What We Heard Report

Access Design Standards Update: Round 2B Technical Feedback Engagement

April 6, 2026

Figure D15.1 – Grate Opening Width

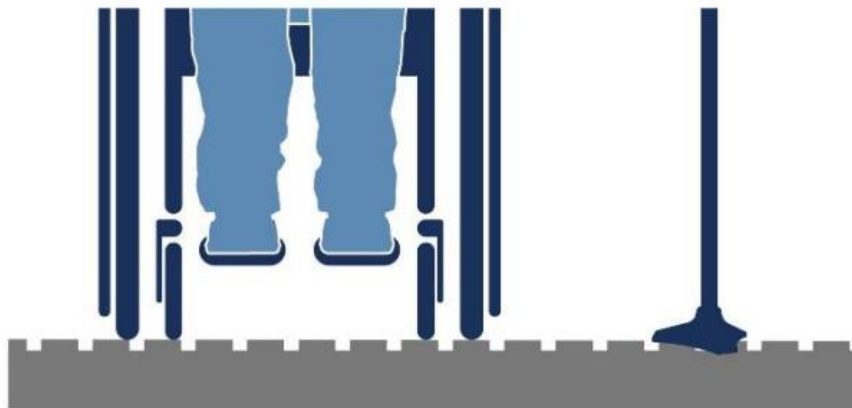
Exterior Paths of Travel	D14	D14 Guy wires within X distance of path of travel (more specific than "along")	
Exterior Paths of Travel	D15	Manhole covers are noted here, however, the City specification for a grated manhole cover has an opening wide of 19mm. Best design practice is to keep these out of walks, but that is not always feasible.	Update/clarify this section.
Exterior Paths of Travel	D15.1	Figure D15.1 - opening are shown parallel to path of travel, not perpendicular as required	
Exterior Paths of Travel	D16	D16 - covers bollard/post placement WITHIN an accessible path of travel (ie: at a pathway entrance) Add clause to cover bollard/post placement between vehicular zones (parking and/or pickup/dropoff) and accessible paths of travel. suggest aligning bollards to fronts and backs of stalls, avoiding "paths" when moving to/from vehicular area.	
Exterior Paths of Travel / General	D17 / General	General note re: colour-contrast How is contrast assessed? Summer vs winter conditions, wet vs dry conditions, day vs night, changing context over time? Is it possible to address visibility without prescribing colour contrast as a criteria?

Figure G4 – Ramp Configurations and Landing Size

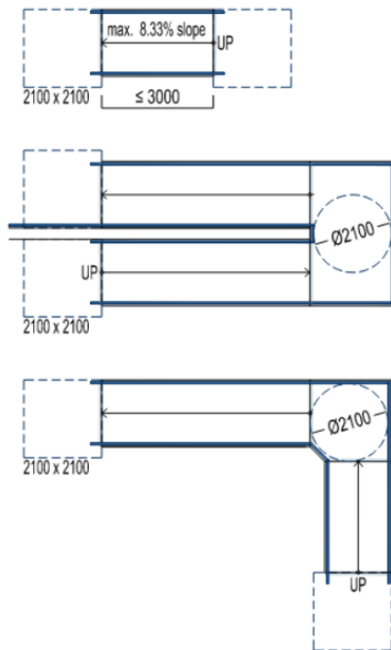
- **Figure G4** showed Ramp Configurations and Landing Size but the slope percentages were not shown and there is a desire to see a slope percentage for each scenario illustration in this figure.

Figure G19 – Handrail Extensions & Attention TWSI

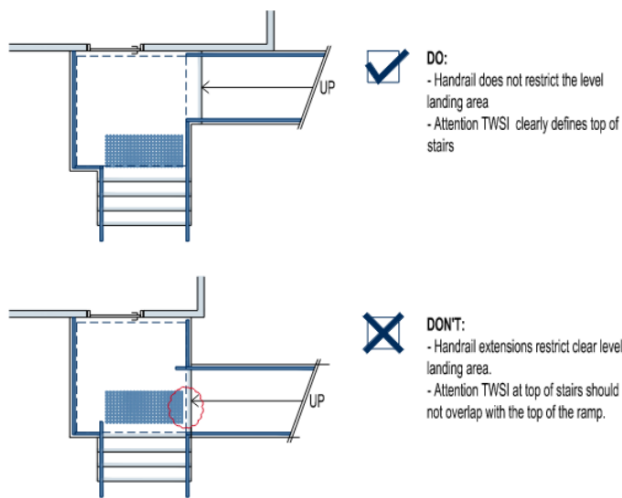
- **Figure G19** showed Handrail Extensions & Attention (tactile walking surface indicators) TWSI, however, Clause G19 in the draft ADS referred to colour contrasted cane-detectable barriers and cantilevered staircases, which appears to be a discrepancy between the two.

Figure G25 – Examples of Handrail Termination to Post, Wall, and Floor

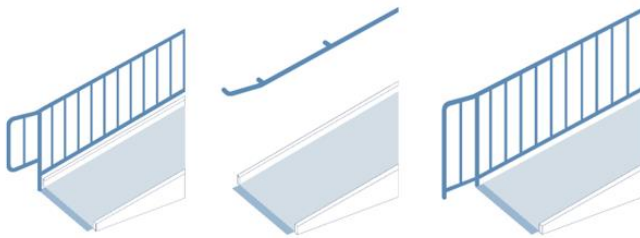
- **Figure G25** showed Examples of Handrail Termination to Post, Wall, and Floor but participants want to see additional detail where the path of travel runs relative to the rail extension.

Figure H4 – Protruding Objects

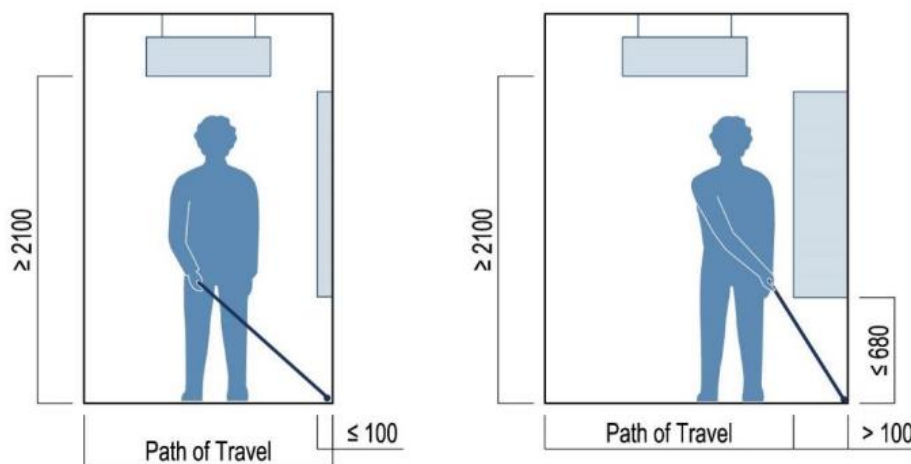
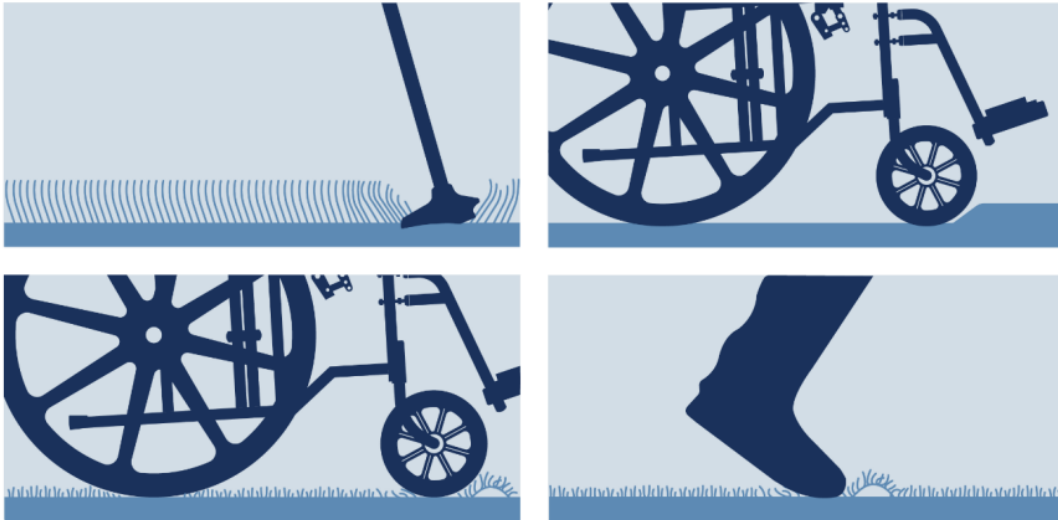
- There are two figures labeled as H4, **H4 – Protruding Objects** and **H4 – Flooring Surfaces**, resulting in duplicate numbering.

G. Ramps, Stairs, Elevators, and Lifts	G36	Item b) sentence ends with “and” but nothing follows	Complete sentence.
Entrances, Exits, Doors and Doorways	G34	Explanation Duplicated from introduction.	
Entrances, Exits, Doors and Doorways	G36	Explanation A general note that belongs in introduction. Expand to provide several scenarios.	
Interior Circulation -	H	There are two Figure H4s on page 74:	TBD

Paths of Travel		Figure H4 – Protruding Objects and Figure H4 – Flooring Surfaces	
Paths of Travel	H	Figure H5 – Beveled Floor Transitions Between Different Flooring on page 75 does not appear to correspond with any of the items in this section.	TBD
Interior Rooms and Services - Mobility Device Storage Areas	I12	Storage space for some mobility devices is smaller than that for a wheelchair and so not all storage spaces need 900mm by 1500mm.	A mobility device storage area shall accommodate at least one mobility storage space with a clear floor area of at least 900mm by 1500mm.
Mobility Device Storage Areas	I13	Missing the word “device”: “...designated space of the mobility storage area.”	Mobility device storage spaces shall be accompanied by signage that identifies the use and designated space of the mobility device storage area.
Meeting Rooms	I24	Add “chairs” to the description and explanation	I24. Tables and chairs on raised platforms shall not be used. Explanation: Tables and chairs on raised platform...

Figure H5 – Beveled Floor Transitions Between Different Flooring

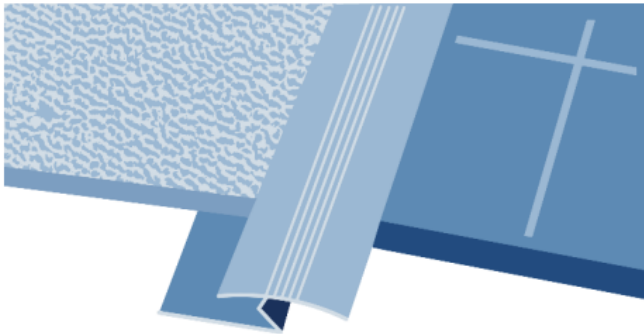
- **Figure H5 – Beveled Floor Transitions Between Different Flooring** does not appear to refer to any of the clauses in the section and requires further clarification.
